Responses in pink provided by EVstudio

**WAGNER
EQUIPMENT**
18000 SMITH ROAD, TOWER
CENTER FOR IND SUB NO. 3,
AURORA, CO 80011

REVISION:
1 06/25/20 COA COMMENTS
DEV PLAN - MINOR MOD
RESUBMITTAL #2 - 11/18/2020

C100

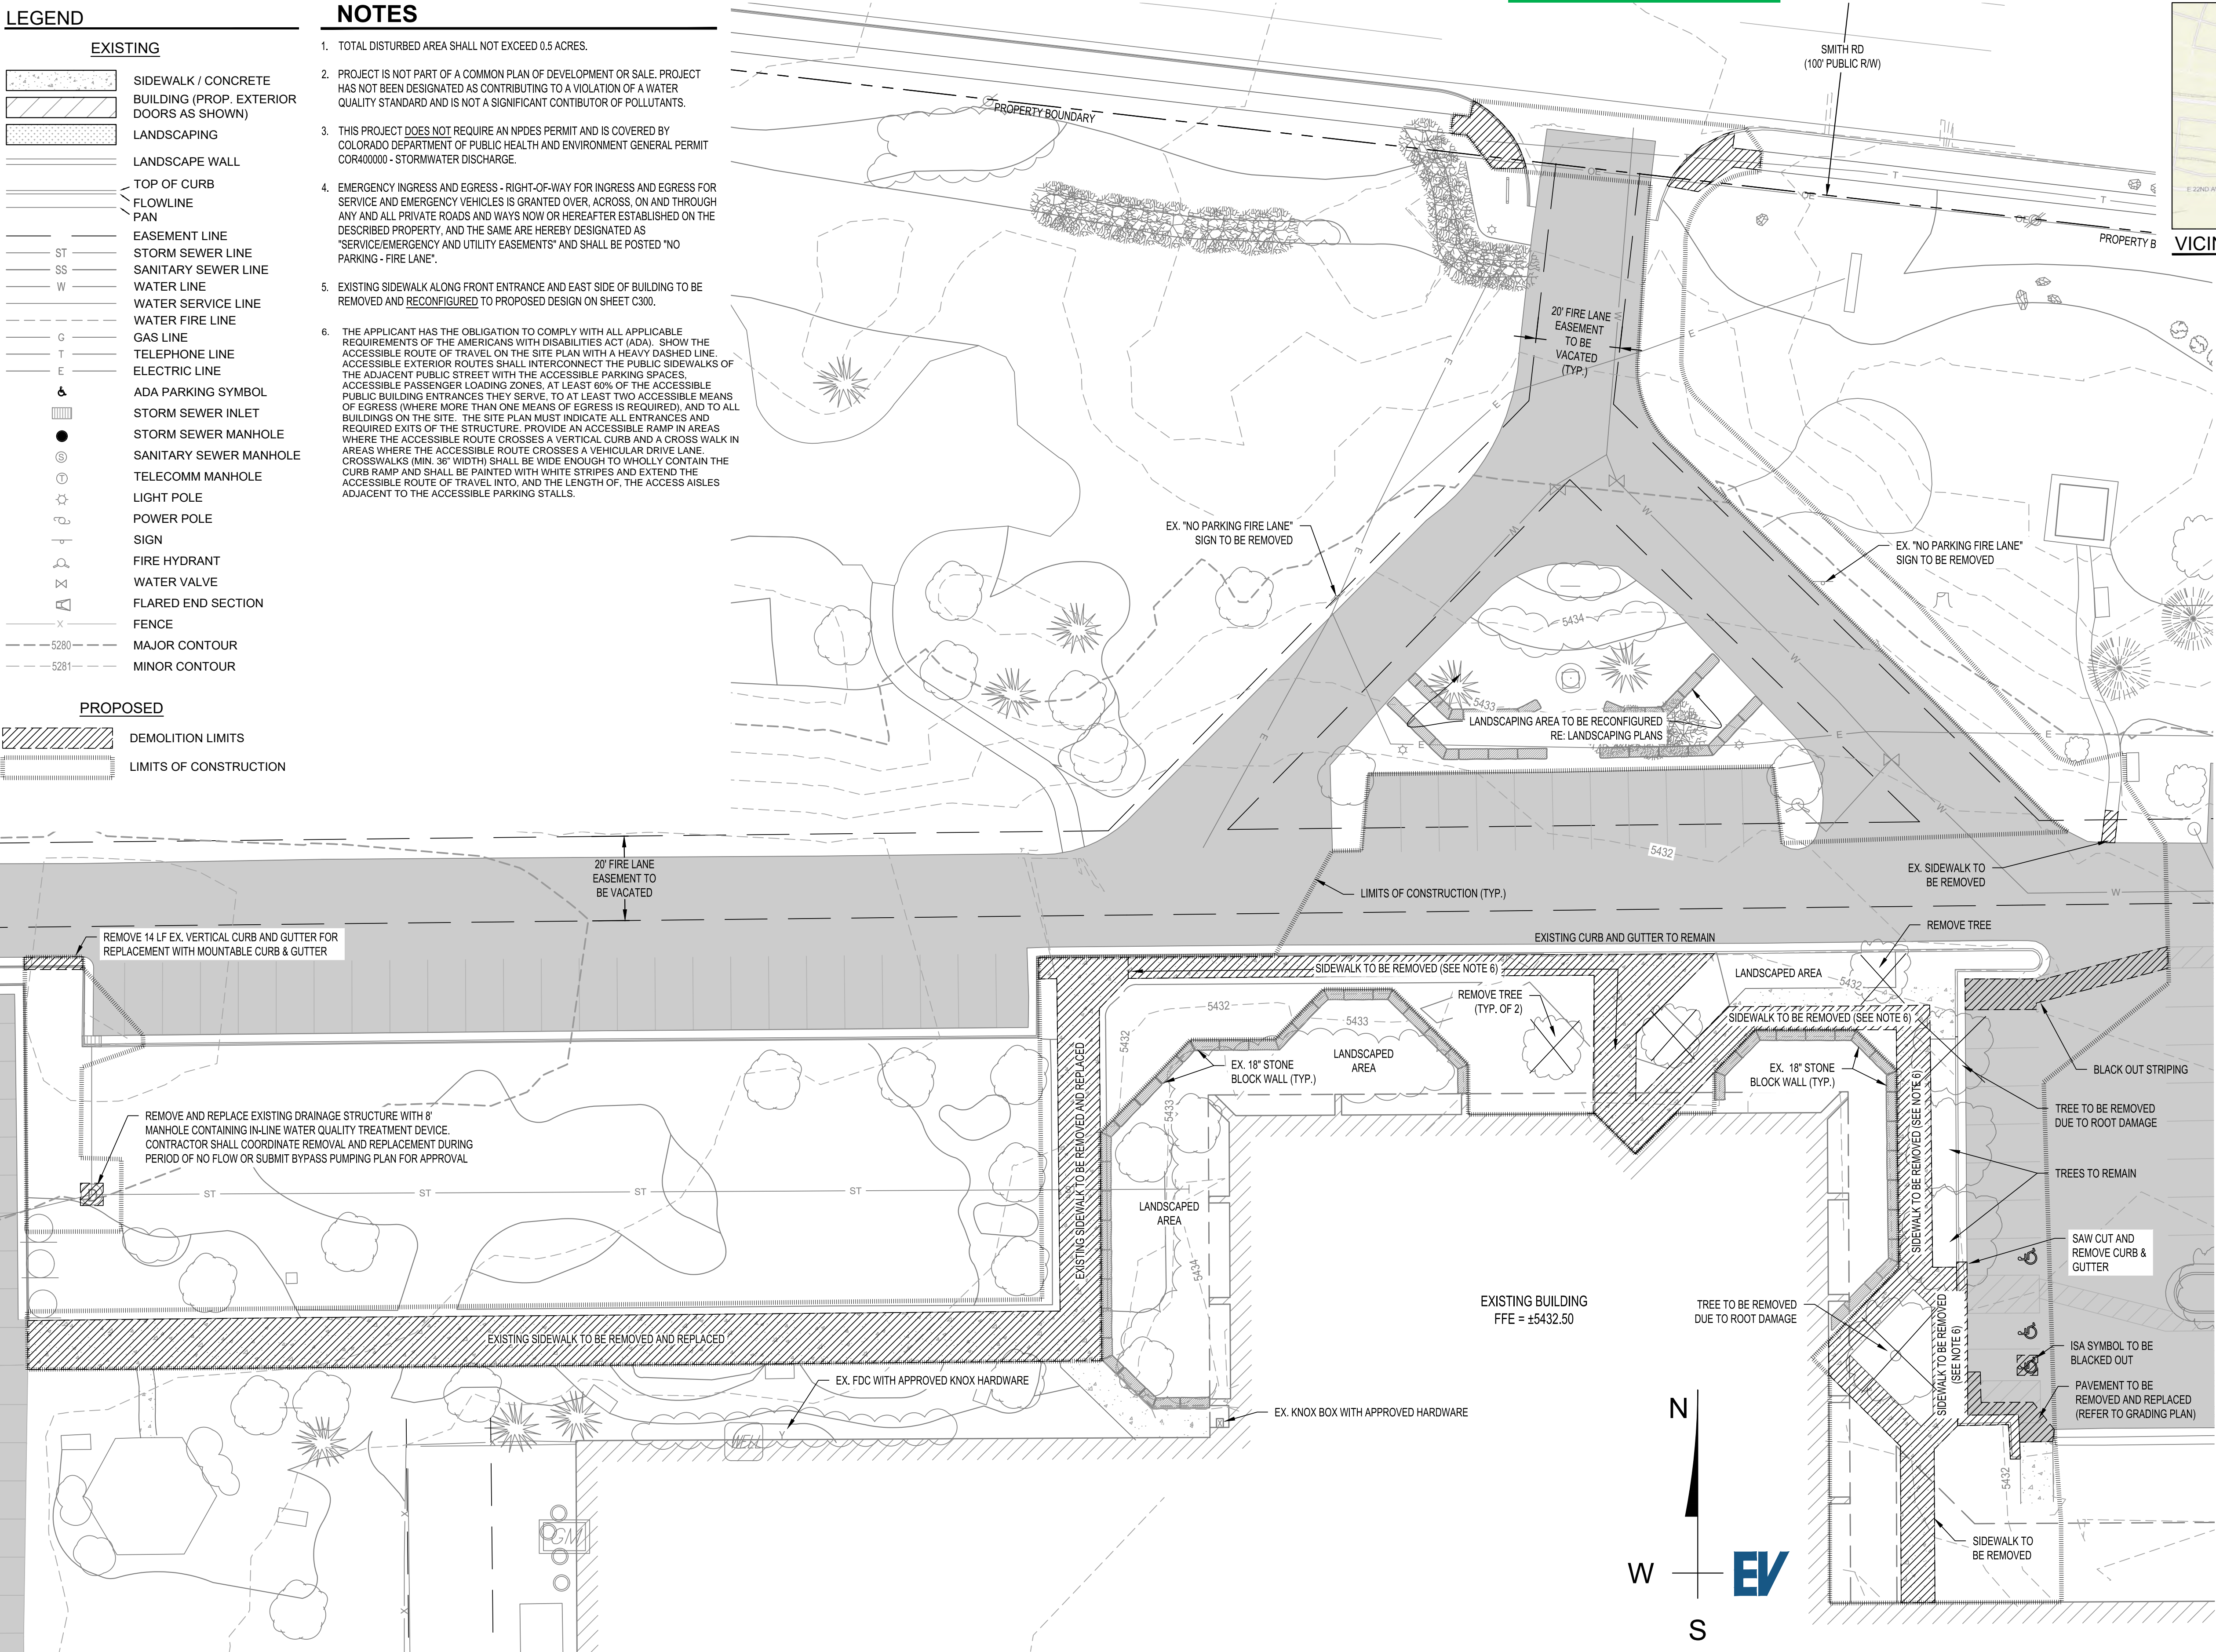
The site plan will not be approved by public works until the preliminary drainage letter/report is approved

Noted.

C201

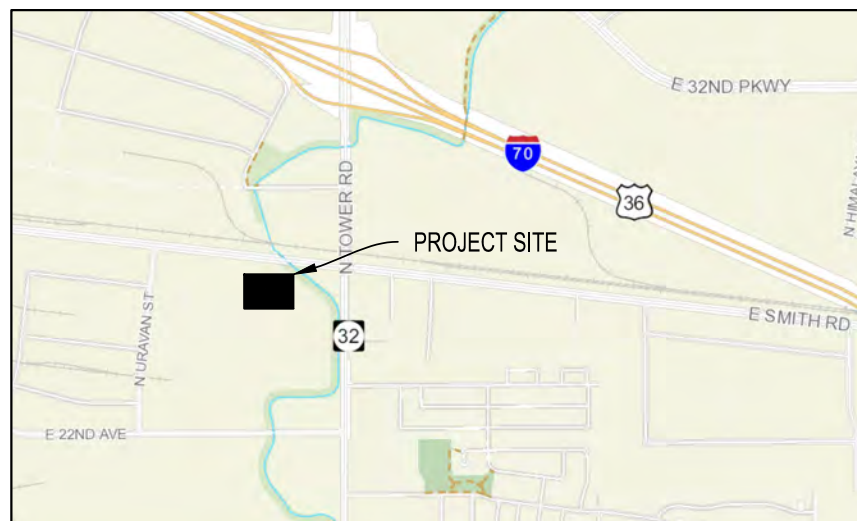
Erosion control plans are not part of the site plan. Please remove

Civil plans are required to review erosion control plans

Erosion control plans are not part of the site plan. Please remove

Civil plans are required to review erosion control plans

This sheet has been removed from the site plan set

This sheet has been removed from the site plan set

L1

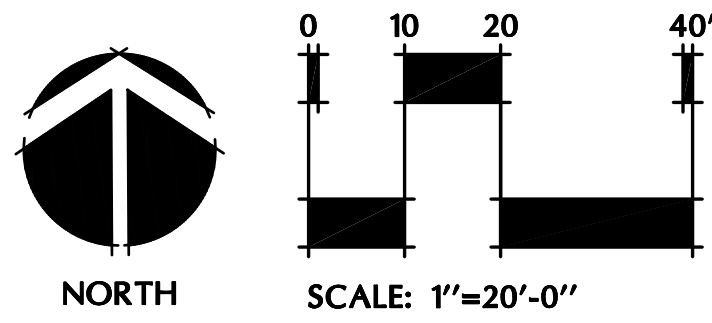
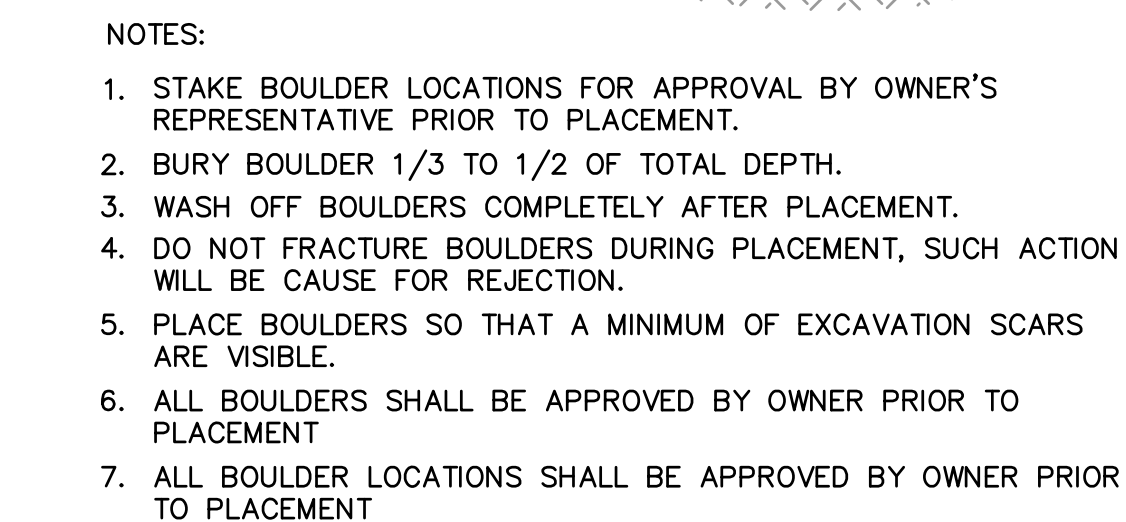
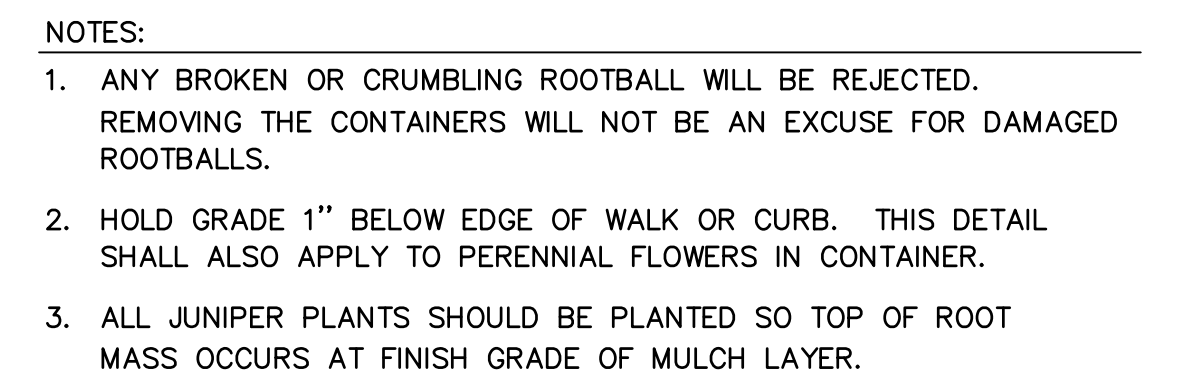
Are there no landscape changes to the area with the added water quality facility and maintenance access?
